UNITED STATES PATENT AND TRADEMARK OFFICE

APPLICATION NO.	FILING DATE	FIRST NAMED INVENTOR	ATTORNEY DOCKET NO.	CONFIRMATION NO.
10/566,290	01/27/2006	Hyun-Jae Yoon	325841040	5463
45263	7590 09/26/2006		EXAMINER	
MITCHELL P. BROOK C/O LUCE, FORWARD, HAMILTON & SCRIPPS LLP 11988 EL CAMINO REAL, SUITE 200			DOAN, JENNIFER	
			ART UNIT	PAPER NUMBER
	SAN DIEGO, CA 92130			
			DATE MAILED: 09/26/200	6

DETAILED ACTION

FIG. 1

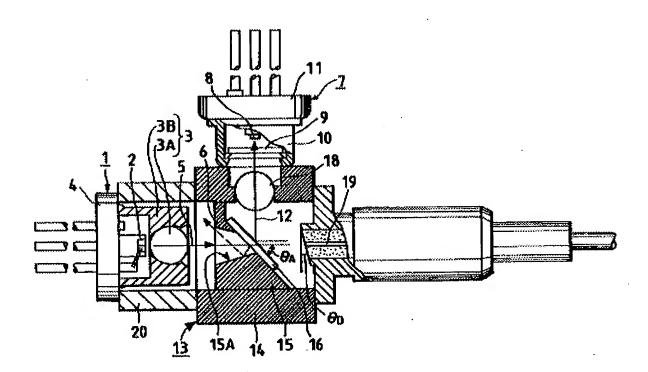
With respect to claim 1, Takahashi et al. (figure 1) disclose a bi directional optical module package having an optical module unit comprising a substrate member (14, 15); an optical filter (16) installed on the substrate member (14, 15) to be inclined with respect to an optical fiber (19); a first holder (20) supported by the substrate member (column 5, lines 28-29) on one side of the optical filter (16) and having a laser diode (2) and a lens (3A) for transmitting an optical signal to the optical fiber (19) through one side of the optical filter (16); and a second holder (see figure 1) supported by the substrate member (column 5, line 51) on the other side of the optical filter (16) and having a photodiode (8) and a lens (18) for receiving the optical signal received through the optical fiber (19).

With respect to claim 3, Takahashi et al. (figure 1) disclose the bi directional optical module package, wherein an optical axis of light transmitted from the laser diode (2) and an optical axis of light received from the photodiode (8) are disposed at right angle with respect to each other with the optical filter (16) being interposed therebetween (see figure 1).

With respect to claim 4, Takahashi et al. (figure 1) disclose the bi directional optical module package, wherein the first holder (20) includes a first base portion (4) having a laser diode (2), a pad and a circuit pattern installed thereon, and first extending portions which extend from both sides of the first base portion to define a fixed position of the lens, and the second holder includes a second base portion (11) having a photodiode (8) installed on an inner surface thereof, and second extending portions

which extend from both sides of the second base portion to define a fixed position of the lens (18).

With respect to claim 5, Takahashi et al. (figure 1) disclose the bi directional optical module package, wherein inclined planes for fixing a position of the optical filter (16) are formed on at least one side of the first extending portions and at least one side of the second extending portions (see figure 1).

With respect to claims 6 and 7, Takahashi et al. (figure 1) disclose a bi directional optical module package comprising an optical fiber (19) which is supported by supporting means (see figure 1); an optical module unit which has a substrate member

(14, 15), an optical filter (16), a first holder (20); and a second holder (see figure 1); the optical filter (16) being installed on the substrate member (14, 15) to be inclined with respect to an optical fiber (19); the first holder (20) supported by the substrate member (column 5, lines 28-29) on one side of the optical filter (16) and having a laser diode (2) and a lens (3A) for transmitting an optical signal to the optical fiber (19) through one side of the optical filter (16); and a second holder (see figure 1) supported by the substrate member (column 5, line 51) on the other side of the optical filter (16) and having a photodiode (8) and a lens (18) for receiving the optical signal received through the optical fiber (19); a stem which supports the optical module unit and has a plurality of pins (see figure 1).

With respect to claim 8, Takahashi et al. (figure 1) disclose the bi directional optical module package, wherein the first holder (20) includes a first base portion (4) having a laser diode (2), a pad and a circuit pattern installed thereon, and first extending portions which extend from both sides of the first base portion to define a fixed position of the lens, and the second holder includes a second base portion (11) having a photodiode (8) installed on an inner surface thereof, and second extending portions which extend from both sides of the second base portion to define a fixed position of the lens (18).

With respect to claim 9, Takahashi et al. (figure 1) disclose the bi directional optical module package, wherein inclined planes for fixing a position of the optical filter (16) are formed on at least one side of the first extending portions and at least one side of the second extending portions (see figure 1).
